Access Compliance Report

Public Rights-of-Way

Intersection ID: 19960	Main Street: ARCHDALE_DR	Cross Street: NETHERWOOD_DR	Location: NE
ADA ID: D5C6AD635A5B	Ramp Type: PerpDiag	Initial Pass/Fail: Fail	Overall Compliance: No
			Severity Score: 21.25

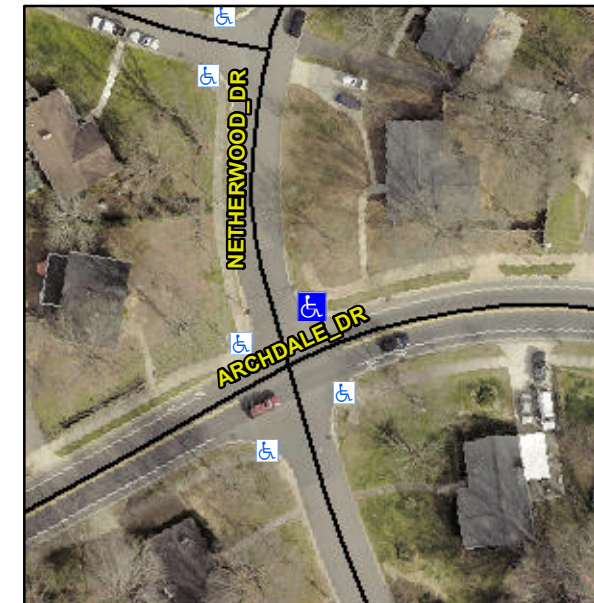
Not Found, R304.5.1, R304.2.2

Compliance	Description	Data	Compliance	Description	Data
N/A	Ramp Length (in)	71.0	No	Ramp Slope (%)	9.6
No	Ramp Width (in)	47.0	Yes	Ramp XSlope (%)	0.8
N/A	Flare Type LT	N/A	N/A	Flare Type RT	N/A
N/A	Flare Slope LT (%)	N/A	N/A	Flare Slope RT (%)	N/A
N/A	Flare Traversable LT?	N/A	N/A	Flare Traversable RT?	N/A
N/A	Landing Length (in)	N/A	N/A	DWS Provided?	N/A
N/A	Landing Width (in)	N/A	N/A	DWS Contrast?	N/A
N/A	Landing Slope (%)	N/A	N/A	DWS Length (in)	N/A
N/A	Landing X Slope (%)	N/A	N/A	DWS Full Width?	N/A
N/A	Landing Curb? (Y/N)	N/A	N/A	DWS Offset (in)	N/A
N/A	Shared Landing?	N/A			
N/A	Gutter Ponding?	N/A	N/A	Gutter Slope (%)	N/A
N/A	Gutter Lip Ht (in)	N/A	N/A	Gutter X Slope (%)	N/A
N/A	Painted X Walk1?	No	N/A	Painted X Walk2?	No
	X Walk 1 Direction	To SW		X Walk 2 Direction	To S
N/A	X Walk 1 Width (in)	N/A	N/A	X Walk 2 Width (in)	N/A
	X Walk 1 Slope (%)	1.1		X Walk 2 Slope (%)	1.1
	X Walk 1 X Slope (%)	1.8		X Walk 2 X Slope (%)	2.1

Remove & Replace Curb Ramp With Two New Directional Ramps or Equivalent.
